[Docket No. FAA-2011-1115; Directorate Identifier 2010-SW-011-AD; Amendment 39-17017; AD 2012-08-01]

#### Airworthiness Directives; Sikorsky Aircraft Corporation Helicopters

##### 2012-08-01 Sikorsky Aircraft Corporation:

Figure 1. Cat 'A' Takeoff and Landing Gross Weight

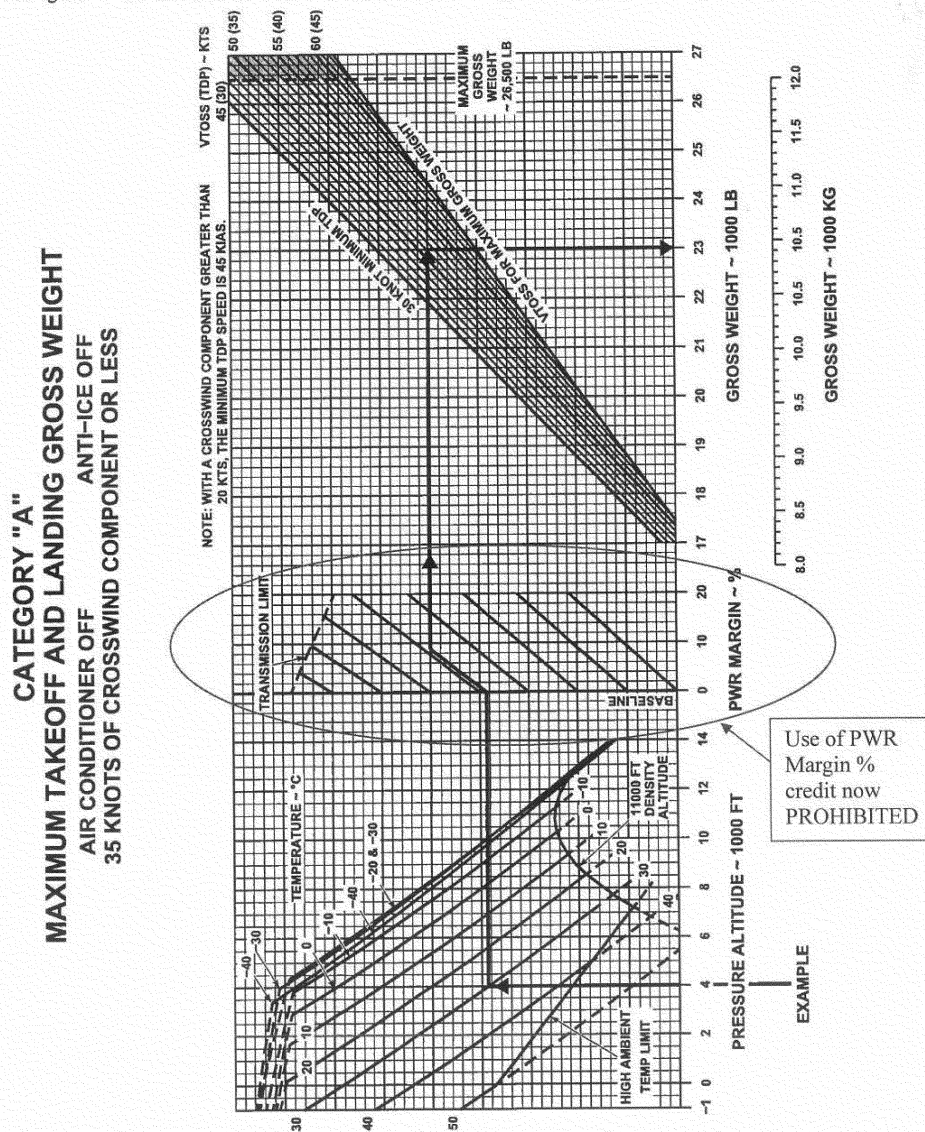
(2) If the RFM already contains the revisions appropriate for your helicopter as listed in the following Table 1, all dated April 9, 2008, with the correct performance charts, without the performance credit as depicted in the circled area of Figure 1 of this AD, the operating limitation required by paragraph (1) of this AD does not need to be inserted into the RFM.

**Note to paragraph (e)(2) of this AD:**  
Previous RFM revisions allowed for the use of above-specification engine power margin as depicted in the circled area of Figure 1 of this AD.

(1) By making pen and ink changes, insert into the Operating Limitations section, Part 1, Section 1, Weight Limits, of Rotorcraft Flight Manuals (RFMs) SA S92A-RFM-002, -003, -004, -005, and -006 the following limitation “Performance credit for above specification engine power margin is prohibited.”
